Access Compliance Report

Public Rights-of-Way

(Curb Ramps)

Intersection ID: 10021759	Main Street: BRIARWICK_LN	Cross Street: BRIARWICK_LN	Location: NE
ADA ID: F9A21F9452F4	Ramp Type: Perp	Initial Pass/Fail: Fail	Overall Compliance: No
Severity Score: 12.5			
Codes/Mitigation Info/Possible Solution		Field Measurements/Component Compliance

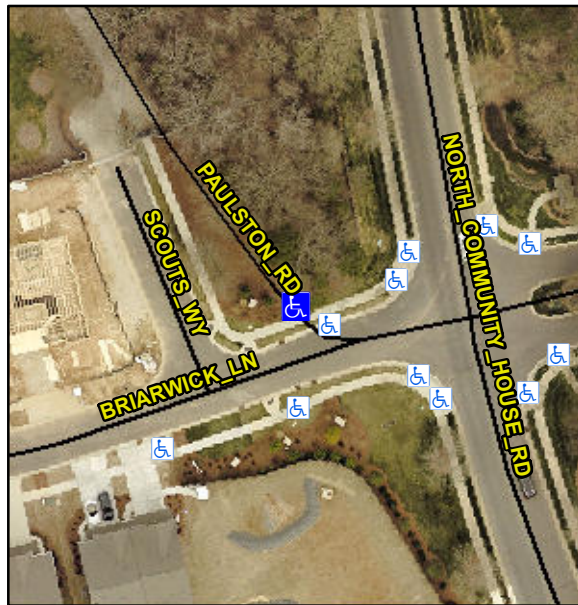
Compliance	Description	Data	Compliance	Description	Data
N/A	Ramp Length (in)	58.0	No	Ramp Slope (%)	8.8
Yes	Ramp Width (in)	57.5	Yes	Ramp XSlope (%)	1.3
N/A	Flare Type LT	N/A	N/A	Flare Type RT	N/A
N/A	Flare Slope LT (%)	N/A	N/A	Flare Slope RT (%)	N/A
N/A	Flare Traversable LT?	N/A	N/A	Flare Traversable RT?	N/A
N/A	Landing Length (in)	N/A	N/A	DWS Provided?	N/A
N/A	Landing Width (in)	N/A	N/A	DWS Contrast?	N/A
N/A	Landing Slope (%)	N/A	N/A	DWS Length (in)	N/A
N/A	Landing X Slope (%)	N/A	N/A	DWS Full Width?	N/A
N/A	Landing Curb? (Y/N)	N/A	N/A	DWS Offset (in)	N/A
N/A	Shared Landing?	N/A			
N/A	Gutter Ponding?	N/A	N/A	Gutter Slope (%)	N/A
N/A	Gutter Lip Ht (in)	1.0	N/A	Gutter X Slope (%)	N/A
N/A	Painted X Walk1?	No	N/A	Painted X Walk2?	N/A
	X Walk 1 Direction	To W		X Walk 2 Direction	N/A
N/A	X Walk 1 Width (in)	N/A	N/A	X Walk 2 Width (in)	N/A
	X Walk 1 Slope (%)	1.6		X Walk 2 Slope (%)	N/A
	X Walk 1 X Slope (%)	1.3		X Walk 2 X Slope (%)	N/A

Remove & Replace Entire Ramp.
